Modifikation von Mikroprozessorkarten

Modification of microprocessor boards

Under part number **20.050.754.12** a **modification kit** is available for all processor cards 1.820.754.12 used in the recorders A820, A820 MCH and A827.

1.820.754.12

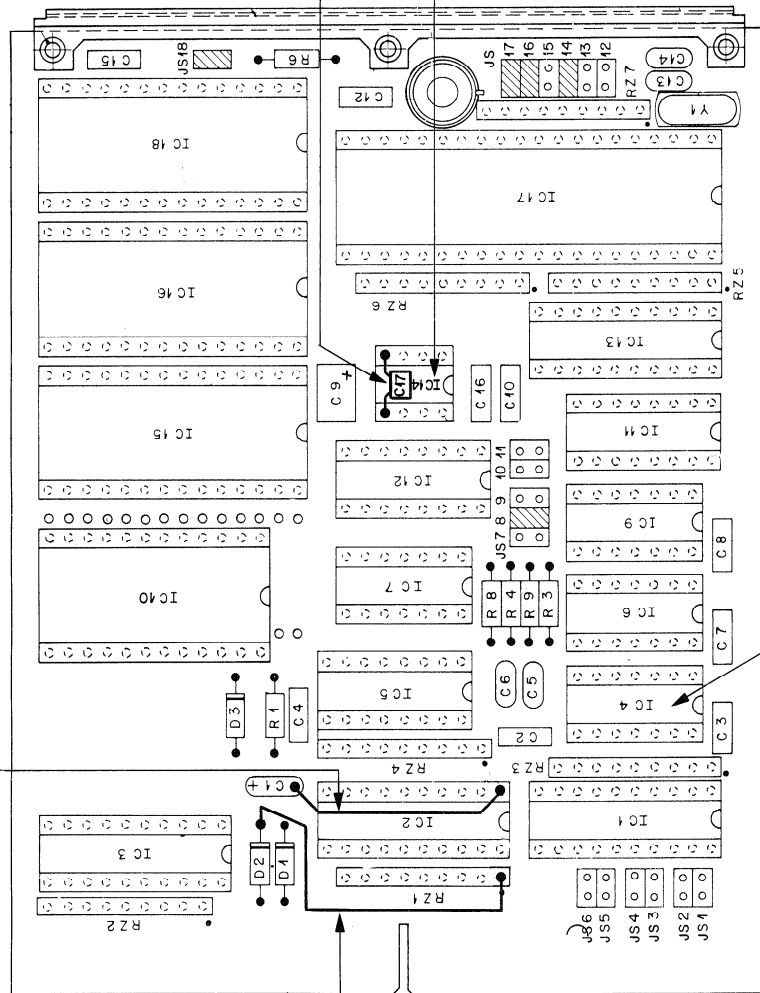
- IC 14, TL 7705 ACP entfernen, dafür neu TL 7705 BCP einsetzen.
- IC 2,2nF zwischen PIN 4 und 5 von IC 14 einlöten.
- IC 4, 74 HC 00 ersetzen durch Typ 74 HC 132.
- Wire-Wrap Draht l=90 von D2 (Kathode) auf PIN 1 von RZ1.
- Wire-Wrap Draht l=80 von C1 (negativ) auf PIN 1 von IC2.
- Neues, um 1 erhöhtes Indexschild auf dem Beschriftungsstreifen anbringen.

- Replace IC 14, TL 7705 ACP with TL 7705 BCP
- Fit C 2,2nF capacitor between pin 4 and 5 of IC 14
- Replace IC 4, 74 HC 00 with 74 HC 132
- Connect cathode of D2 with pin 1 of RZ1 (wire length 90mm)
- Connect C1 (negative) to pin 1 of IC2 (wire length 80mm)
- Fit index label of next higher number to legend strip.

WIRE WRAP 80mm
1.010.108.64 ★

WIRE WRAP 90mm
1.010.109.64 ★

2,2nF, 10%, 63V
59.06.0222 ★

IC14 CHANGE TO TL 7705 BCP
50.11.0157

IC4 CHANGE TO 74 HC 132
50.17.1132
